### **BP 21-129 Encina Middle School**

#### **Infill Office Wall and Exterior**

#### **Flatwork, ADDENDUM NO. 2**

**April 30, 2021**

**AD2 - 1**

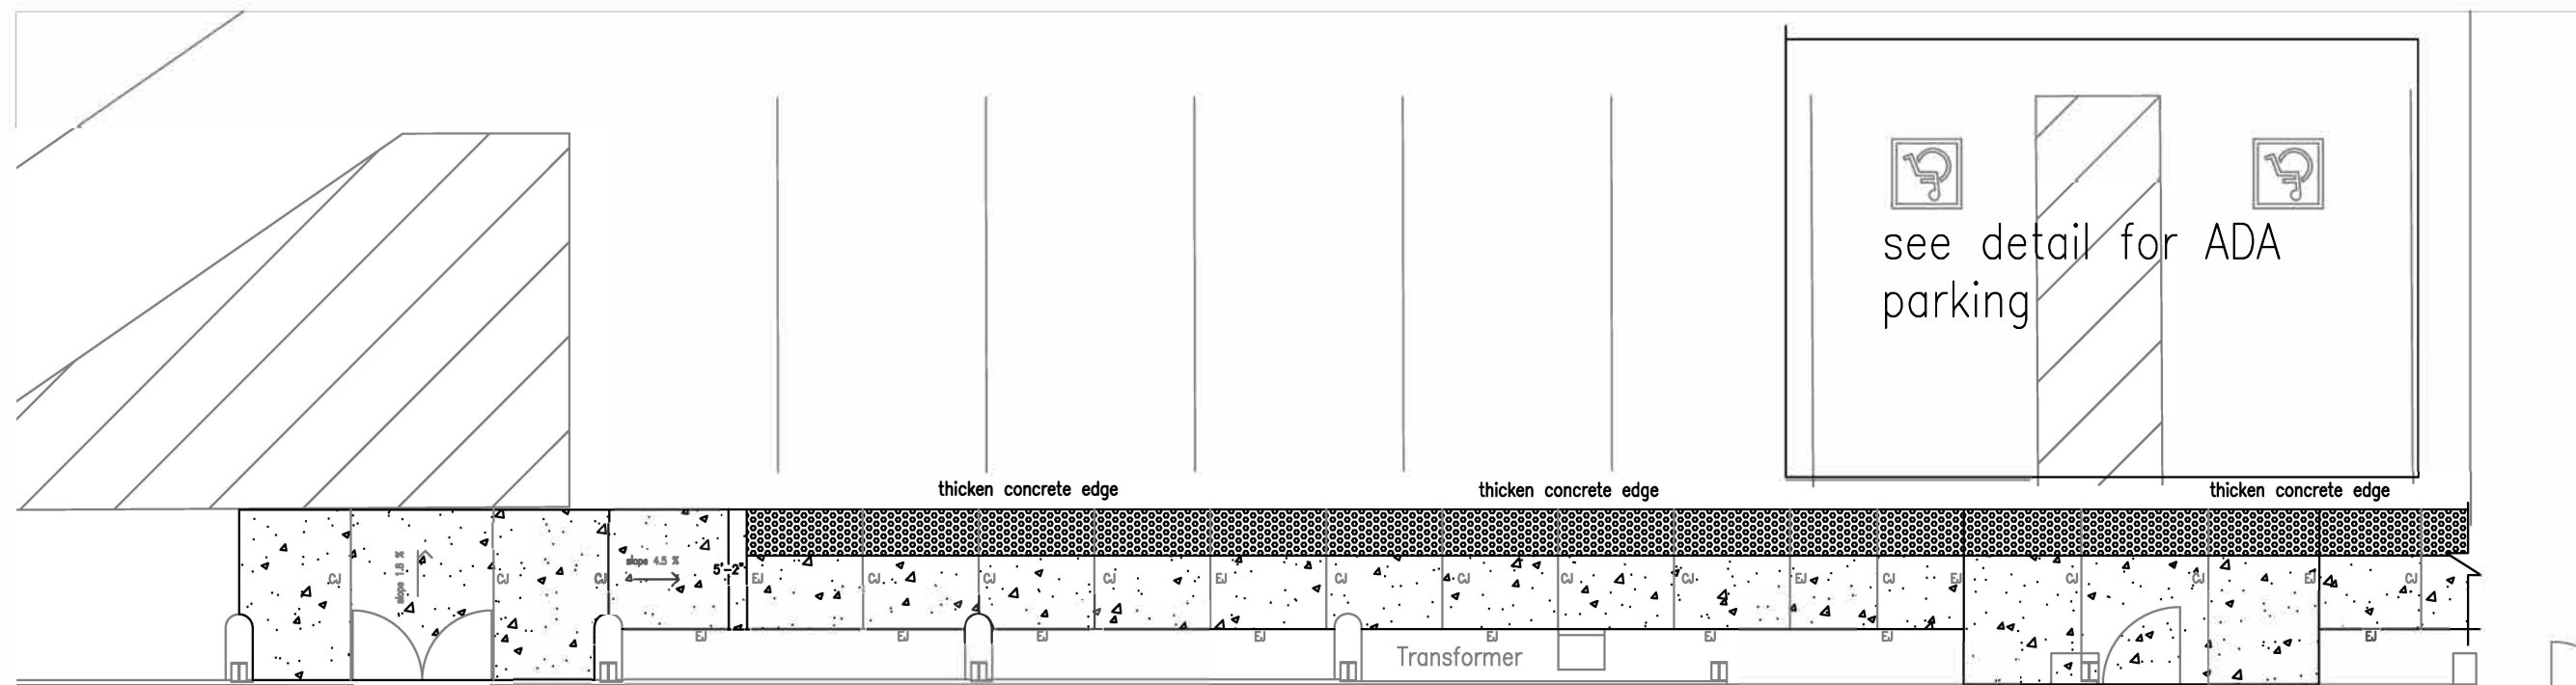
**PART C – DRAWINGS: New Drawing**  
**Replace in its entirety AD1-1 with AD2-1.**
